This page lists the know errors on the gm5x5x5 PCBs. There are no known issues with the bulk order run (white pcbs), the following information is valid **only** for the prototype run (green pcbs).

Bulk Order #1 (white pcb, rev 1.0)

Prototype Run (green PCBs)

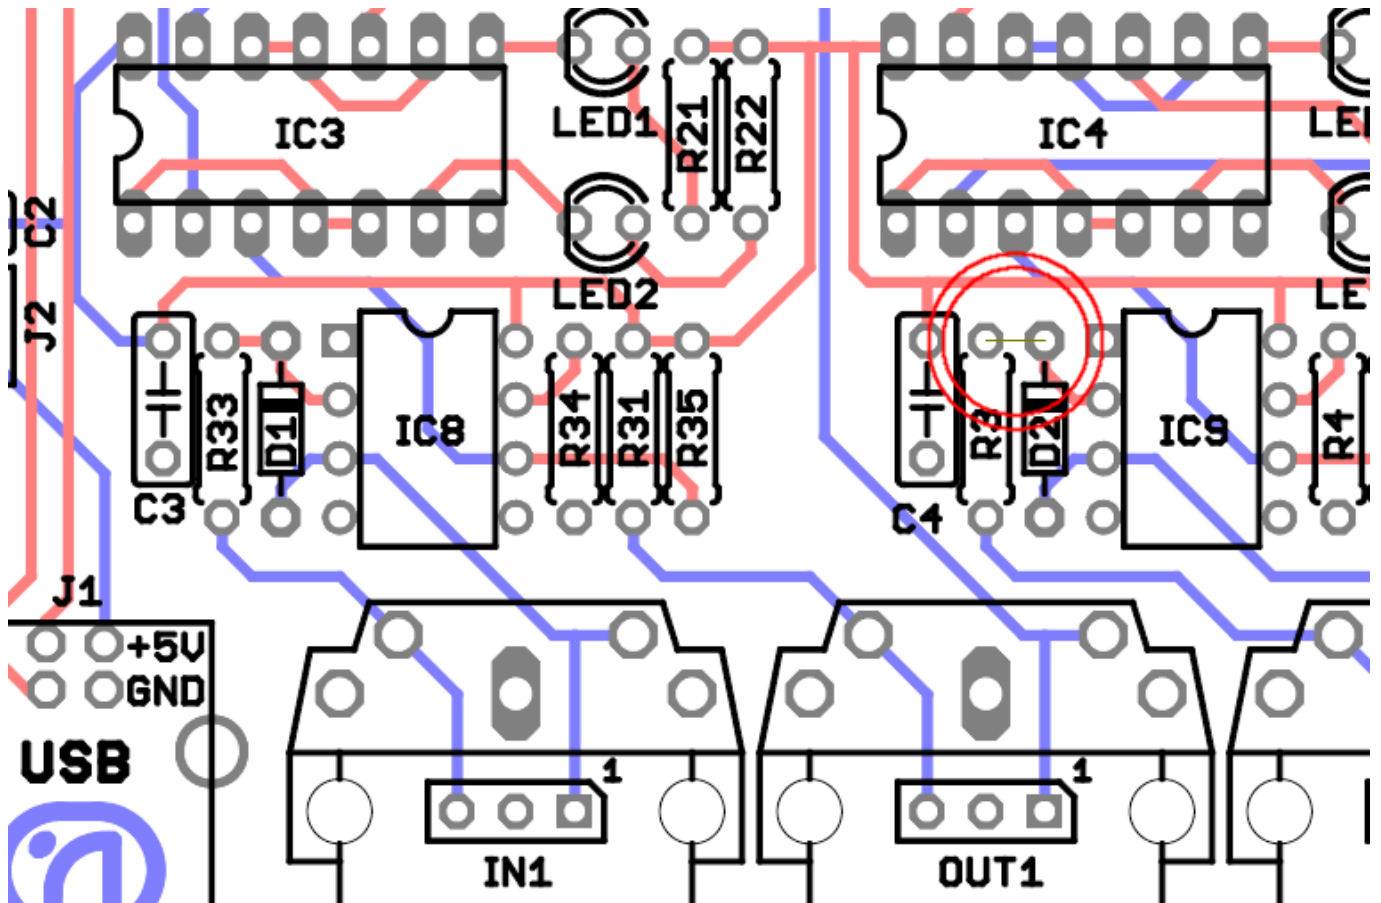
#1 MIDI IO pins

Problem: The MIDI IO pins of the midi sockets (Pin 4 + 5) are switched.

#2 MISSING TRACK

Problem: A track between D2 and R3 is missing.

Solution: Either (1) use the pin-headers if you use sockets that are not mounted on the pcb or (2) break the traces to pins 4 + 5 of the sockets and solder wires to them or (3) solder the midi sockets on the other side of the pcb.

Solution: Bridge the pins.
